15a Parliament Hill New House

12.05.2016 Proposed Section: b/2

P/1:50/202/b/2

# b/2

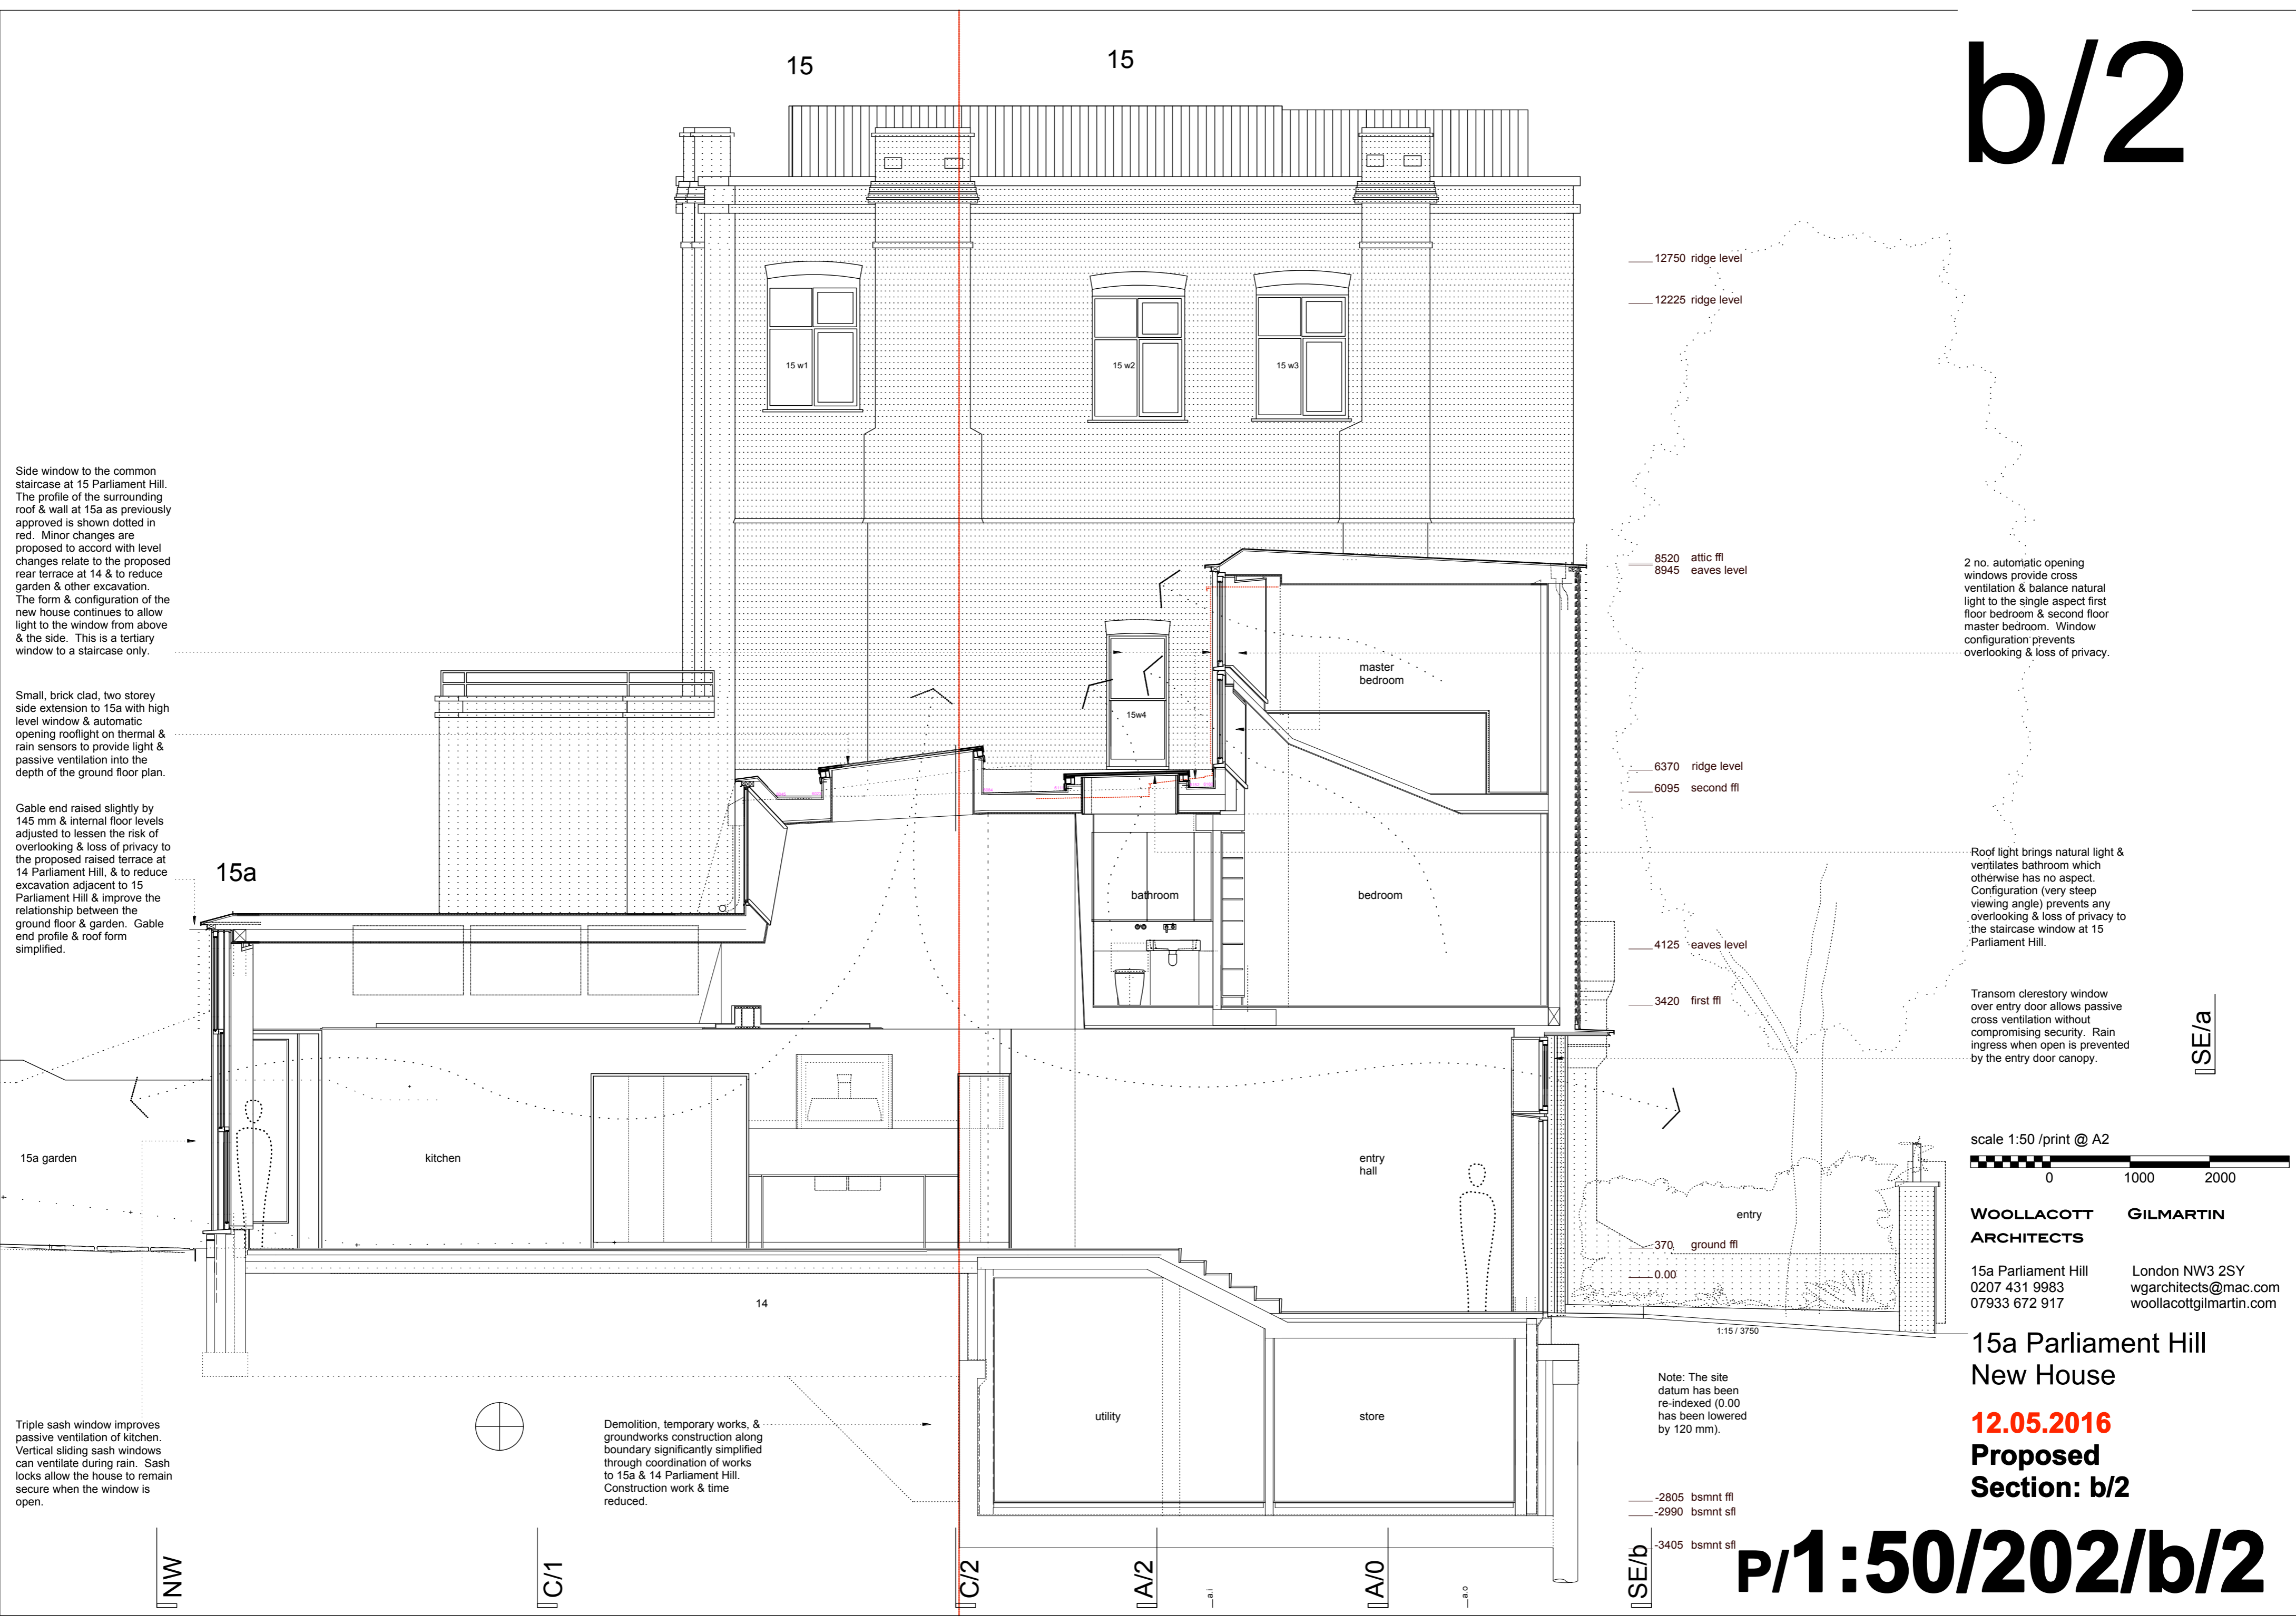
Side window to the common staircase at 15 Parliament Hill. The profile of the surrounding roof & wall at 15a as previously approved is shown dotted in red. Minor changes are proposed to accord with level changes relate to the proposed rear terrace at 14 & to reduce garden & other excavation. The form & configuration of the new house continues to allow light to the window from above & the side. This is a tertiary window to a staircase only.

Small, brick clad, two storey side extension to 15a with high level window & automatic opening rooflight on thermal & rain sensors to provide light & passive ventilation into the depth of the ground floor plan.

Gable end raised slightly by 145 mm & internal floor levels adjusted to lessen the risk of overlooking & loss of privacy to the proposed raised terrace at 14 Parliament Hill, & to reduce excavation adjacent to 15 Parliament Hill & improve the relationship between the ground floor & garden. Gable end profile & roof form simplified.

Triple sash window improves passive ventilation of kitchen. Vertical sliding sash windows can ventilate during rain. Sash locks allow the house to remain secure when the window is open.

Demolition, temporary works, & groundworks construction along boundary significantly simplified through coordination of works to 15a & 14 Parliament Hill. Construction work & time reduced.

2 no. automatic opening windows provide cross ventilation & balance natural light to the single aspect first floor bedroom & second floor master bedroom. Window configuration prevents overlooking & loss of privacy.

Roof light brings natural light & ventilates bathroom which otherwise has no aspect. Configuration (very steep viewing angle) prevents any overlooking & loss of privacy to the staircase window at 15 Parliament Hill.

Transom clerestory window over entry door allows passive cross ventilation without compromising security. Rain ingress when open is prevented by the entry door canopy.
